National Committee on Uniform Traffic Control Devices (NCUTCD)

Recommended Changes to Proposed Text for 11th Edition of the MUTCD

Docket Number: FHWA-2020-0001

NPA MUTCD Section Number: Sections 9C.01 – 9C.09

Figure 9C-1. Warning Signs and Plaques and Object Markers for Bicycle Facilities (Sheet 1 of 2)

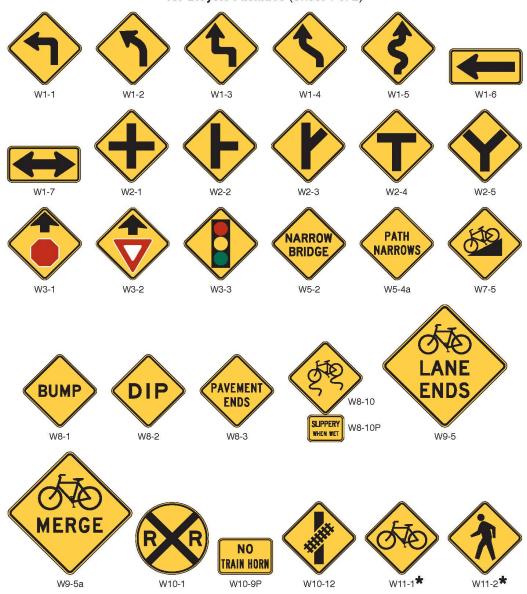
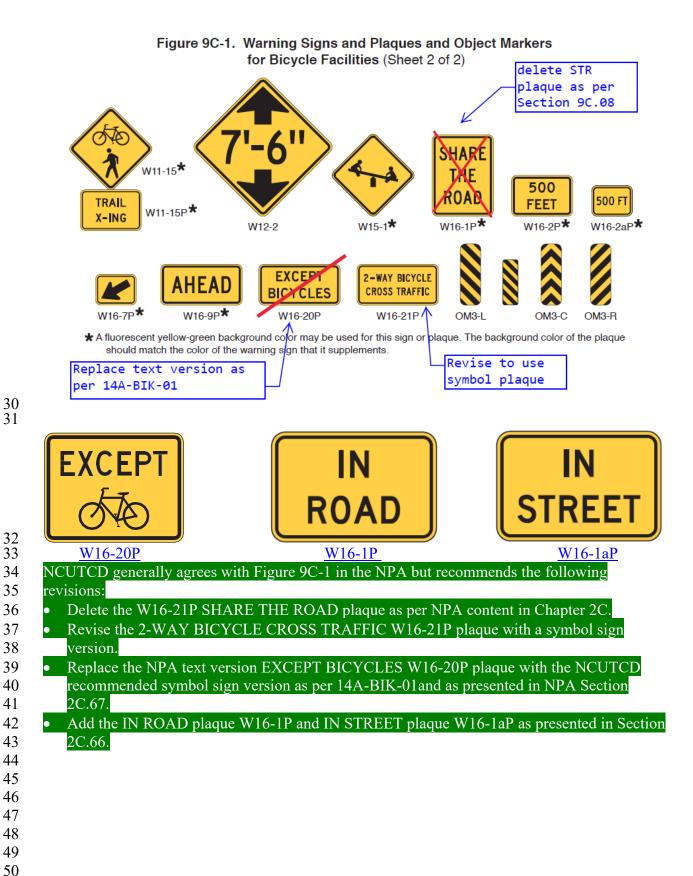
Section 9C.08 Comments: NCUTCD generally agrees with 9C.08 as presented in the NPA but recommends revision to add IN STREET plaque W16-1aP and delete SHARE THE ROAD plaque as per Section 2C.66.

In situations where there is a need to warn <u>road users</u> to watch for <u>bicycles</u> traveling along the <u>roadway</u>, the <u>BICYCLE</u> warning sign (W11-1) may be used with the <u>IN</u>

<u>ROAD plaque (W16-1P) or the IN STREET plaque (W16-1aP)</u>. <u>and W16-1aP</u>
